August 11, 2005  
LIC-05-0083

**SUBJECT: Fort Calhoun Station Unit No. 1 License Amendment Request (LAR),  
"Tri-sodium Phosphate Volume"**

**Mark-up of Technical Specification Pages**

Figure 2-3

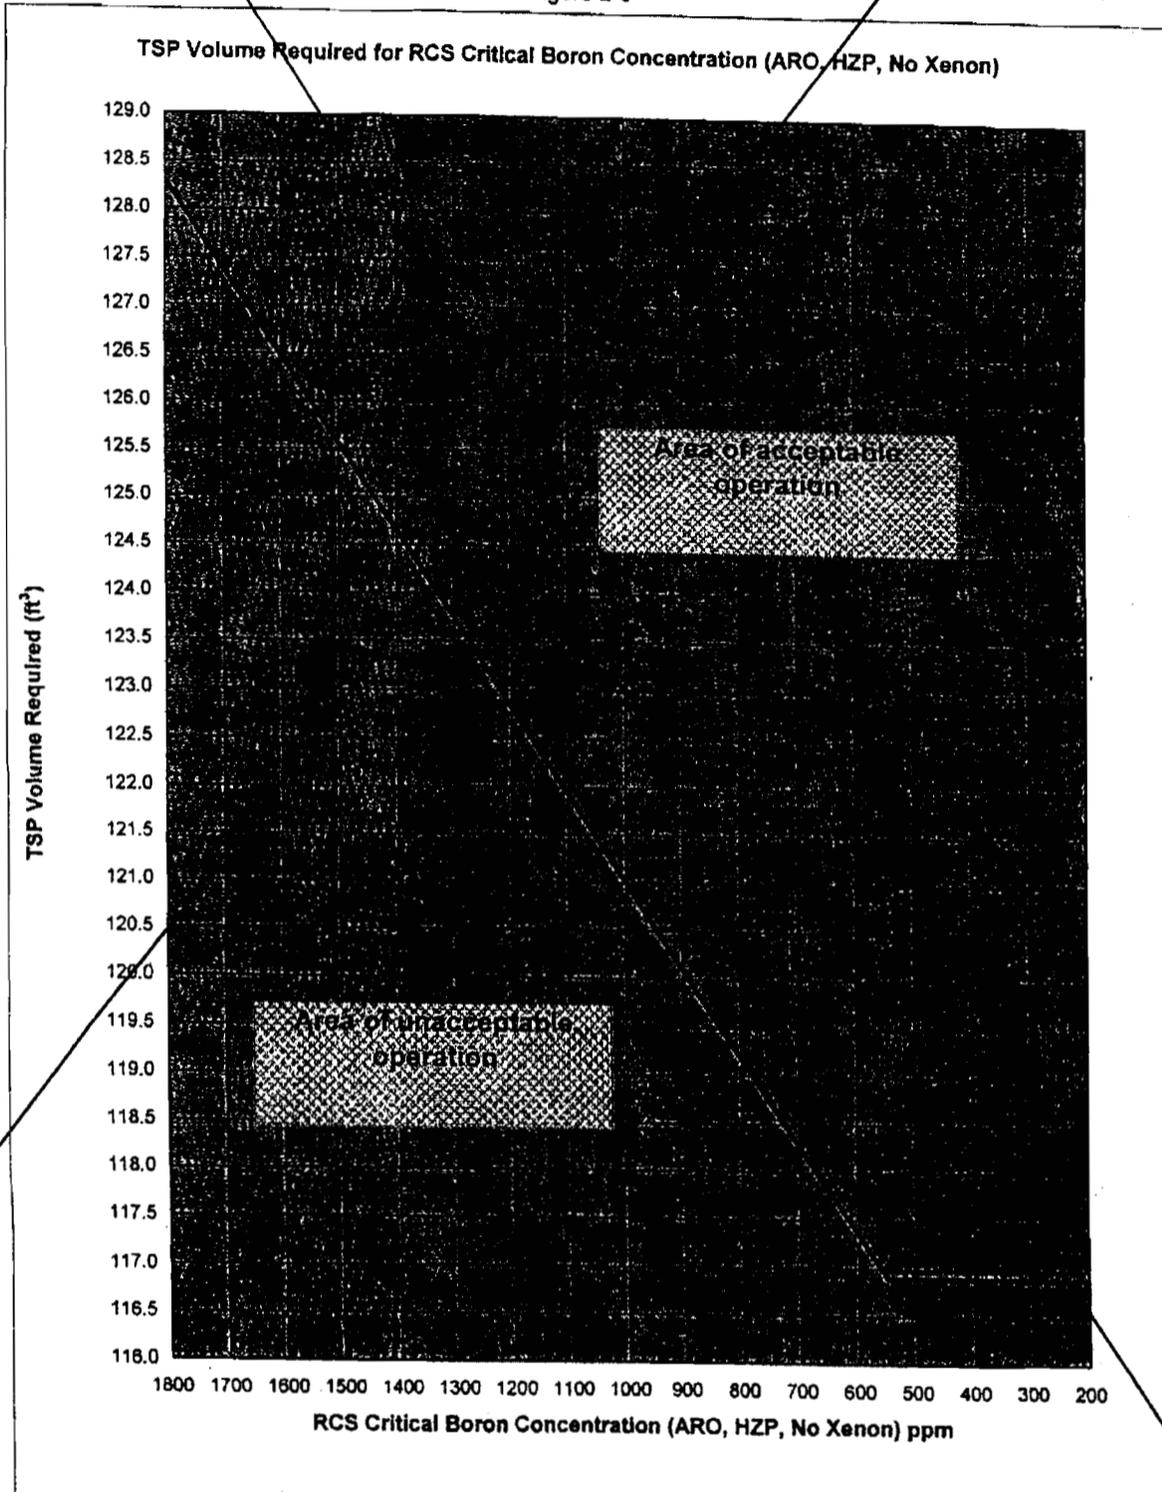
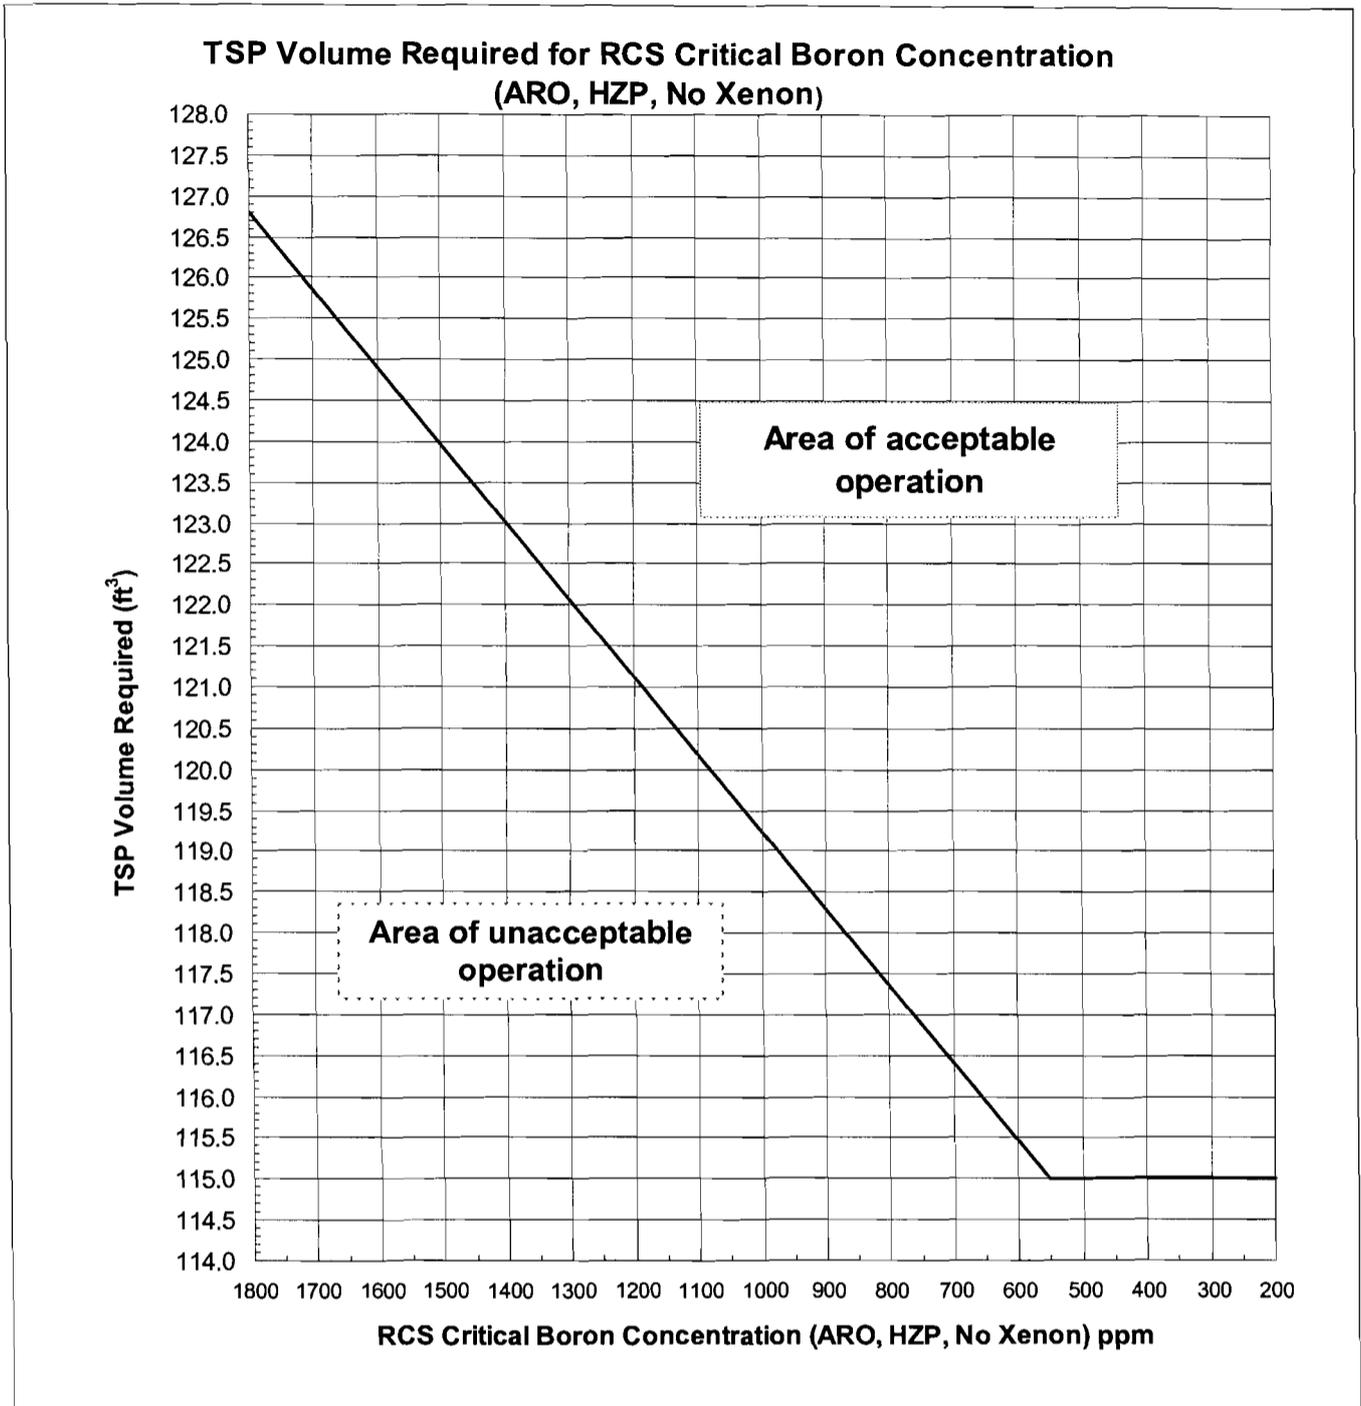
The proposed revision to Figure 2-3 shows the same downward trend in TSP requirement but with revised endpoints. The figure is being revised to account for the change in RCS volume due to the replacement of major components and due to removing excessive conservatism in accounting for radiolysis products. At an RCS HZP CBC of 1800 ppm, 126.8 ft<sup>3</sup> of TSP is required. RCS HZP CBC in the range of 550 ppm to 200 ppm requires 115.0 ft<sup>3</sup> of TSP. The TSP requirements outlined in this figure bound expected HZP CBC for any operating cycle. This proposed revision to Figure 2-3 utilizes the same methodology established in Amendment 232 (Reference 7.7). Also, TS 3.6(2) is being revised to remove the term Dodecahydrate to be consistent with FCS TS Amendment No. 232 (TAC No. MC3214).

The proposed amendment to TS 2.3(4) revises the graph shown in Figure 2-3 to show a new minimum required volume of TSP versus HZP CBC over the operating cycle. This revised figure has a minimum required TSP volume of 126.8 ft<sup>3</sup> at the beginning of cycle (BOC) and a minimum required TSP volume of 115.0 ft<sup>3</sup> at the end of cycle (EOC). Based on historical data, the BOC HZP CBC is bounded by 1800 ppm, and EOC is bounded by 550 ppm. The EOC HZP CBC could be less than 550 ppm, so the curve is extended as a horizontal line at this point.

Figure 2-3 of TS 2.3 is revised to show the new areas of acceptable and unacceptable operation for the volume of TSP required over the operating cycle versus HZP CBC. The Basis of TS 3.6 is revised to update the TSP volume requirements, the sump volume, the sump boron concentration, and the engineering analysis reference. TS 3.6(2) is revised to remove the term Dodecahydrate to be consistent with FCS TS Amendment No. 232 (TAC No. MC3214).

Replace with new  
Figure 2-3

*New Figure*

The proposed change to TS 2.3(4) and 3.6 Basis will replace the current TSP requirement with a new curve. The new curve still shows a decreasing TSP requirement with decreasing RCS HZP CBC but with revised endpoints. Compliance with Figure 2-3 will ensure that a containment sump pH range of 7.0 to 8.0 will meet EEQ, iodine, and hydrogen generation design basis objectives.

During the 2006 refueling outage, OPPD will replace both steam generators and the pressurizer. These new components will increase the maximum possible post LOCA sump volume from 397,183 gallons to 398,444 gallons. This change requires a new TSP requirement curve to be generated. Additionally, several conservatisms previously utilized to calculate the amount of TSP needed to neutralize hydrochloric and nitric acids generated as a result of degradation of electric cable jacket material and radiolysis of sump water and air were re-evaluated. The new analysis, which remains consistent with the guidance provided in NUREG-CR 5950, removes some of the inappropriate conservative assumptions previously utilized. Specifically, the following assumptions were removed: a) a post accident dose integration period greater than 30 days, b) inclusion of the IEEE 323 10% safety margin on the dose estimate (applicable only to equipment qualification), and c) inclusion of the total integrated dose contribution due to normal operation over plant life in addition to the 30-day accident dose contribution.

OPPD's engineering analysis (Reference 7.5) determined that compliance with Figure 2-3 will continue to provide a neutral or slightly basic pH in the containment sump following a LOCA. While the end of cycle HZP CBC could be somewhat less than 550 ppm, the allowable volume of TSP is not reduced below that required at 550 ppm, as indicated by the horizontal line on Figure 2-3.

Figure 2-3

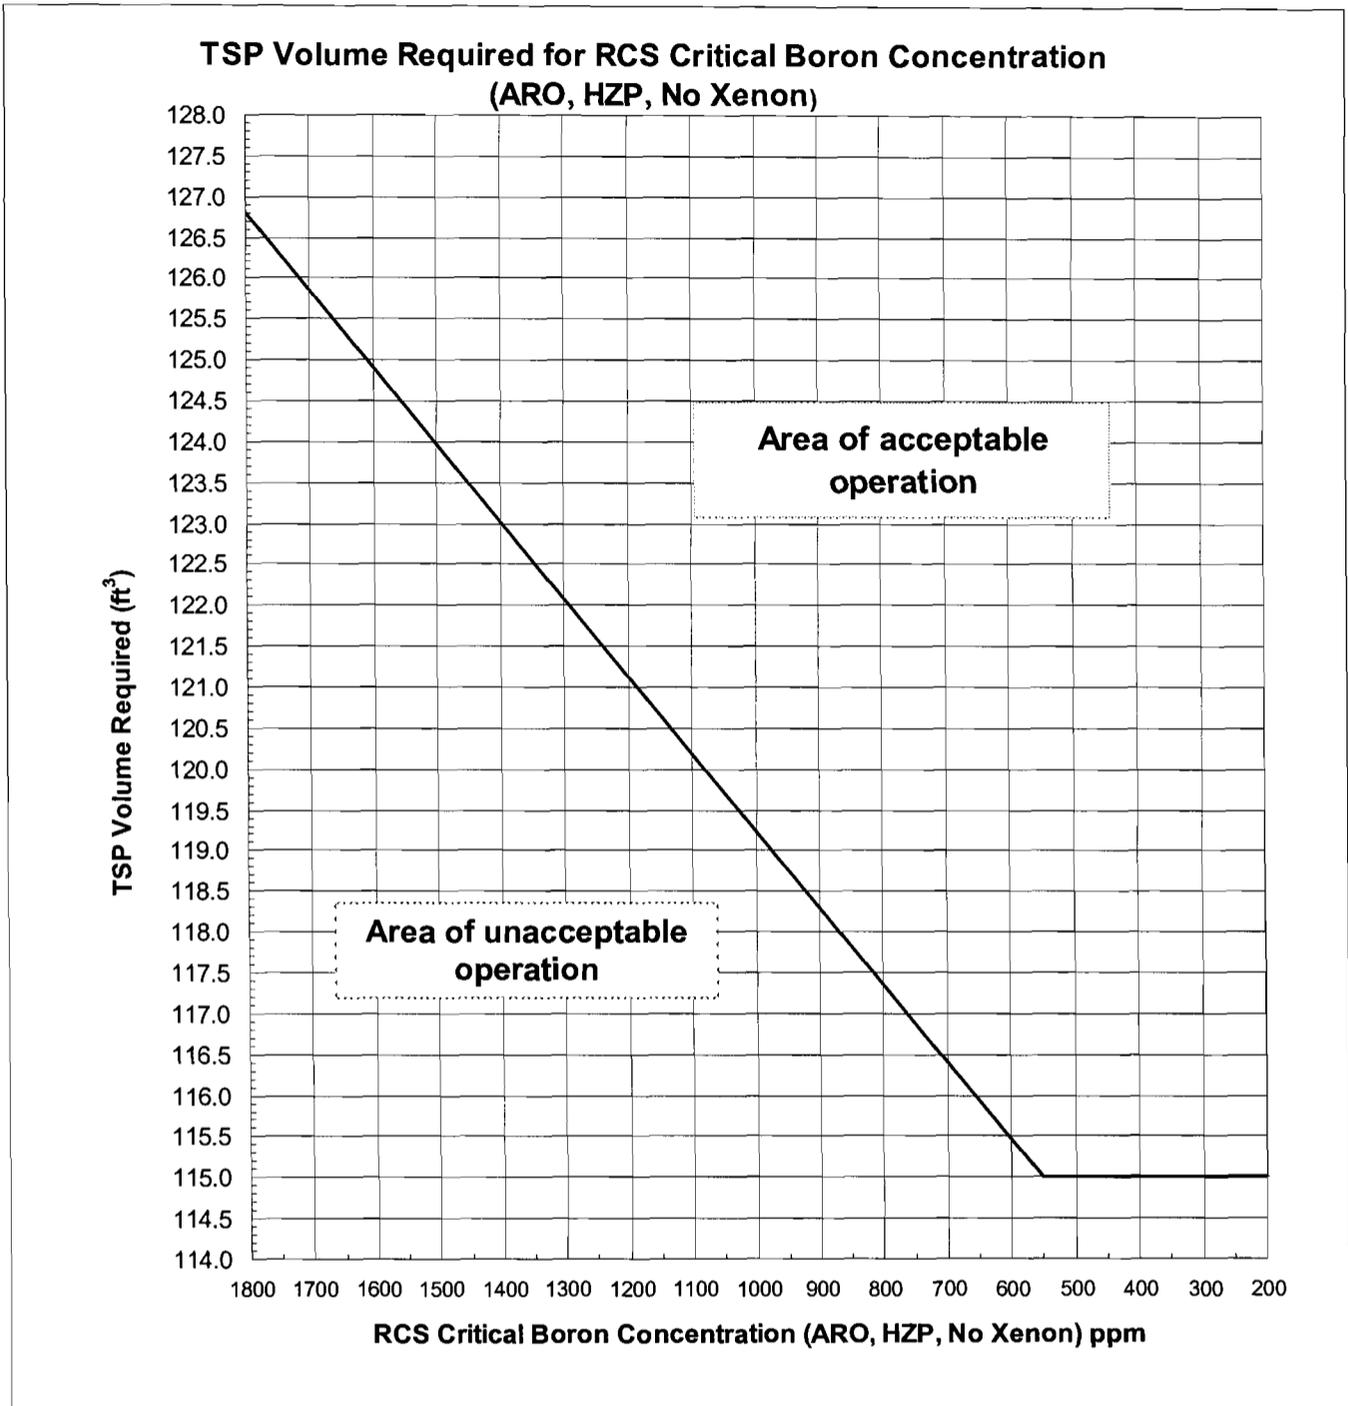
## **Proposed Technical Specification Pages**
